Mirvac Harbourside Architectural Design Report  
Section 4.55 Modification to Apartment Planning

29 April 2023

Mirvac Harbourside Development

# Proposed Modifications

EXAMPLE OF APARTMENT INTERNAL PLANNING CHANGES

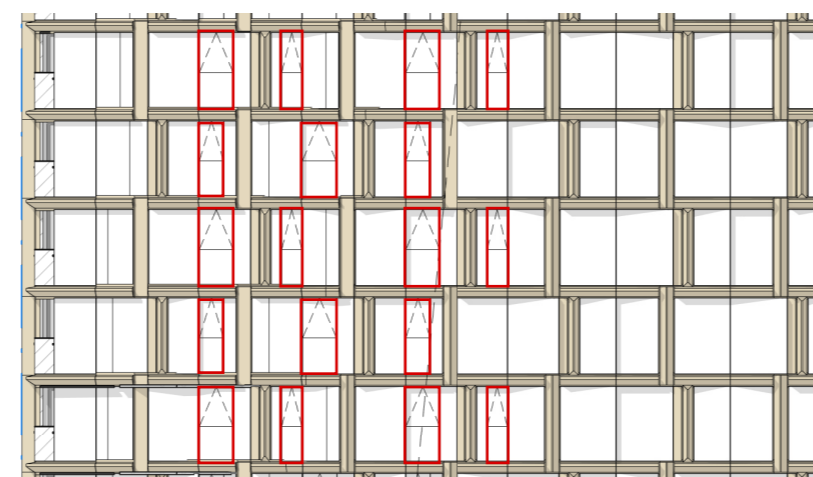
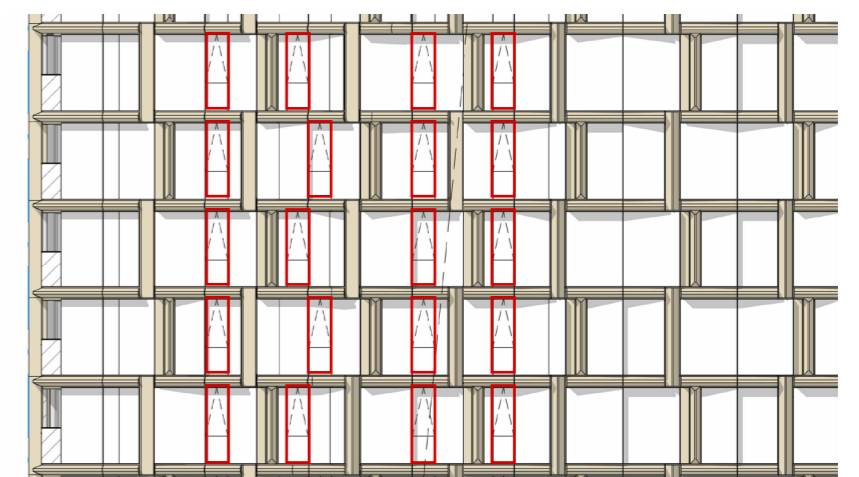
1. Adjustment to internal planning of apartments
2. Adjustment to riser sizes and locations
3. Adjustment to window sizes and locations
4. Adjustment to spandrel positions
5. Coordination of riser sizes and integration of maintenance access doors
6. Relocation and revised planning of Silver Liveable and Adaptable apartments
7. Change of 13 total 3 Bed + Study apartments on levels 29-41 to 4 Bed apartments as a result of internal apartment planning improvements

ELEVATION: PREVIOUS WINDOWS - VARIABLE WIDTHS  
DIAGRAM 1

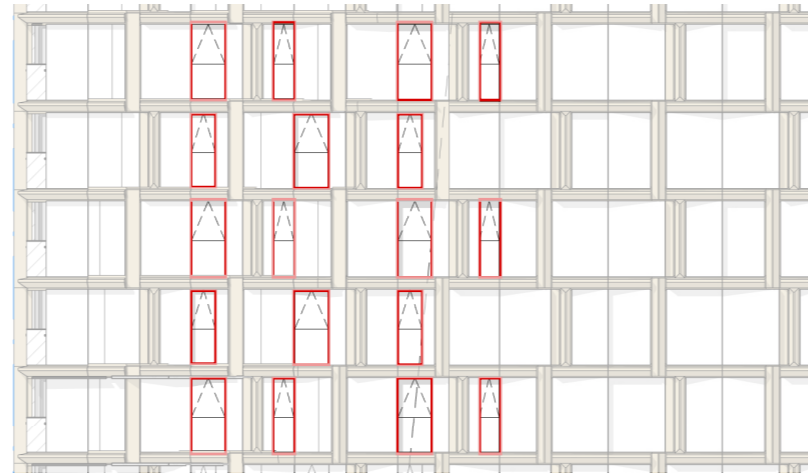
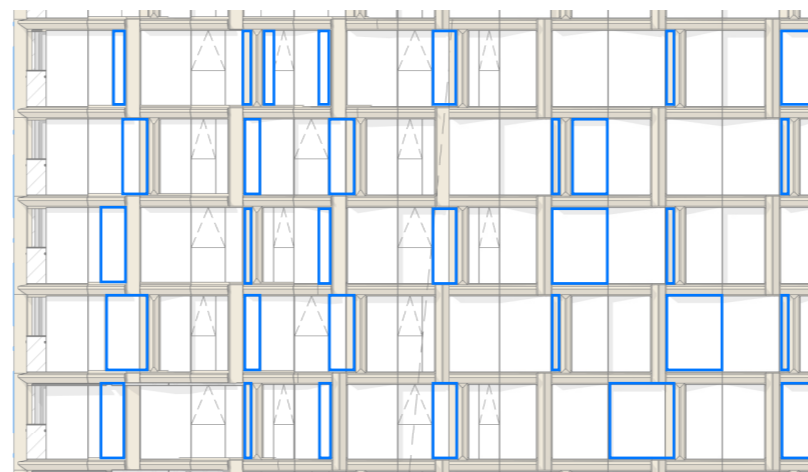
DIAGRAM 1: Adjustment to window sizes and locations

- The approved SSDA2 design featured a variety of window widths in a staggered arrangement. The proposed modification seeks to maintain the staggered nature of the windows, ensuring variety across the facade. Window widths have been rationalised to a consistent width across the elevation, resulting in a more refined outcome.

ELEVATION: PROPOSED WINDOWS - CONSISTENT WIDTHS

ELEVATION: PREVIOUS SPANDRELS LOCATED TO SUIT INTERNAL PLANNING  
DIAGRAM 2

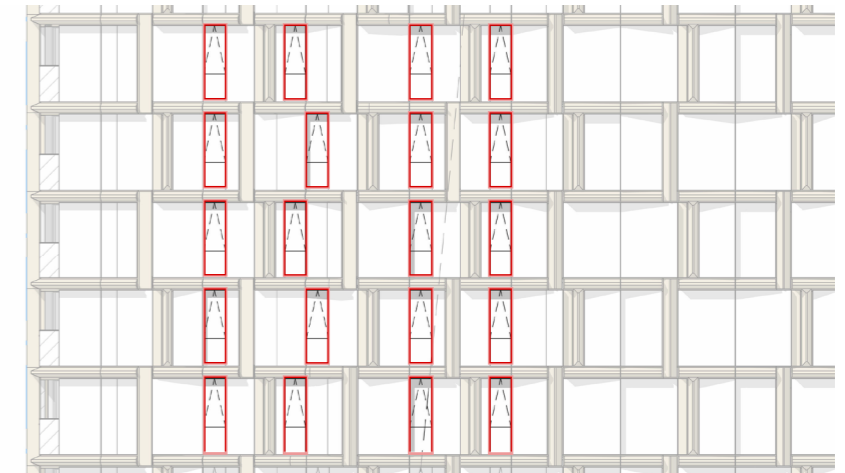
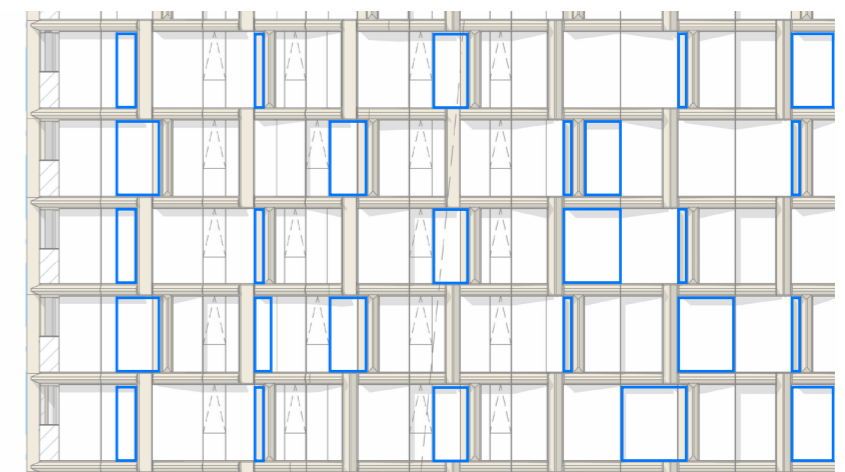
DIAGRAM 2: Adjustment to spandrel positions

- The approved SSDA2 integrated spandrels where internal planning required
- As a result of the internal replanning, the spandrel panels have also been adjusted to meet the new layout.

ELEVATION: PROPOSED SPANDRELS ADJUSTED TO SUIT INTERNAL RE-PLANNING

## Facade Design - Horizontal Fins

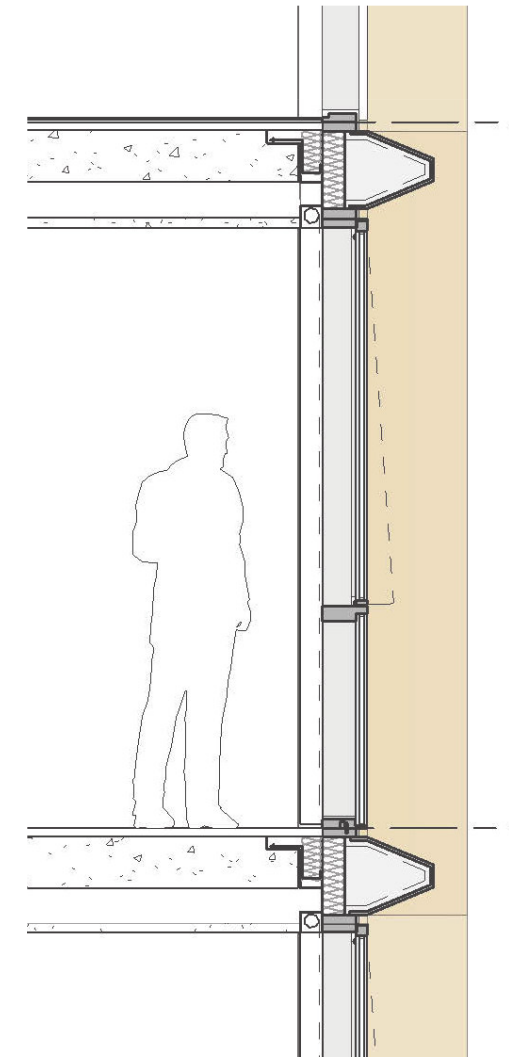
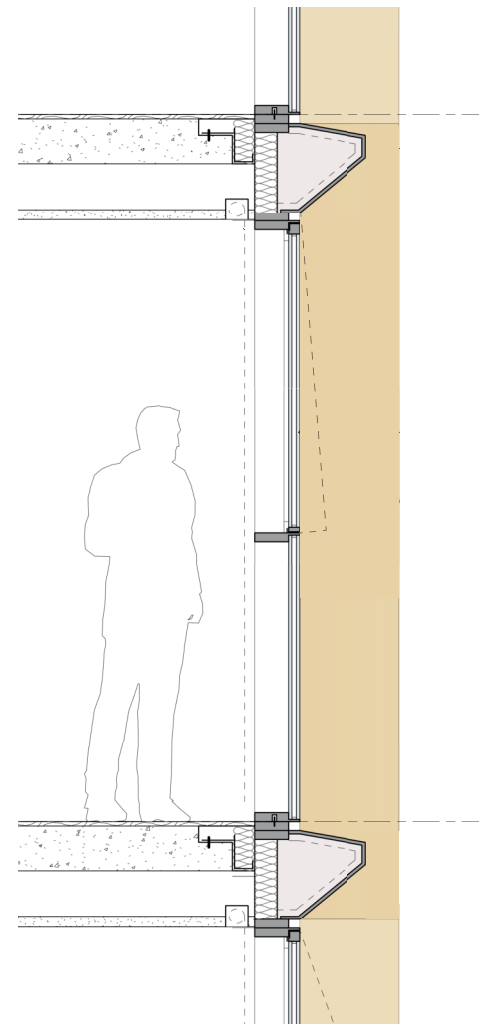
Minor dimensional refinements have occurred to the horizontal fins since the approved design during design development. These minor refinements are consistent with the design intent of the competition scheme and the approved design.

Throughout design development the depth and articulation of shading elements remains unchanged from the approved design. However, the angle of the shading fins has slightly adjusted to a centered position to better align with the sun angles on each facade and view planes. This adjustment also enhances bird mitigation and water runoff, ensuring the long-term maintenance and appearance of the tower. As a result, the articulation of the tactile woven net expression is increased and improved.
